Work Order ID 88436

Item Name: Crosstube Fwd High

DRAWING NO. D212-664-141	TITLE XTUBE ASSY (205/212/412 HI FWD)	REV. D	DART AEROSPACE LTD ENGINEERING ORDER		D.E.O. NO. D212-664-141-D-1	SHEET NO. SHEET 1 OF 2	SCALE NTS
DRAWN	CHECKED <i>RP</i>	MFG. APPR. <i>R</i>	APPROVED <i>MA</i>	DE APPR. <i>MA</i>			
DATE 11.04.07	DATE 11.04.11	DATE 11.04.12	DATE 11/04/12	DATE 11.04.12

ADD AN INSPECTION WINDOW TO UNDERSIDE OF CROSSTUBE.

**D212-664-141/-141B
ASSEMBLY DETAIL**

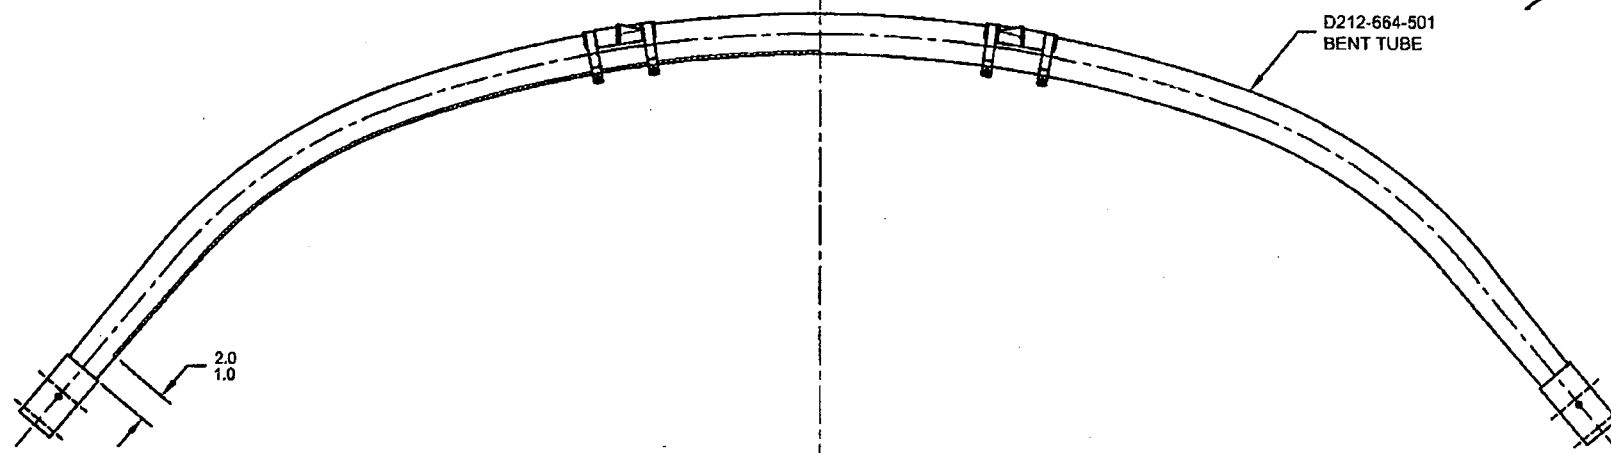
NOTES 2 OF SHEET 1 IS AMENDED AS FOLLOWS:

MASK AREA PRIOR TO PAINTING.
REMOVE MASKING AFTER PAINT
AND APPLY CLEAR COAT

- 2) FINISH: CHEMICAL CONVERSION COAT PER DART QSI 005 4.1
PRIME INSIDE AND OUTSIDE PER DART QSI 005 4.2
MASK UNDERSIDE OF CROSSTUBE AS SHOWN (HATCHED AREA) AND
PAINT OUTSIDE PER DART QSI 005 4.2
REMOVE MASKING AND APPLY CLEAR COAT
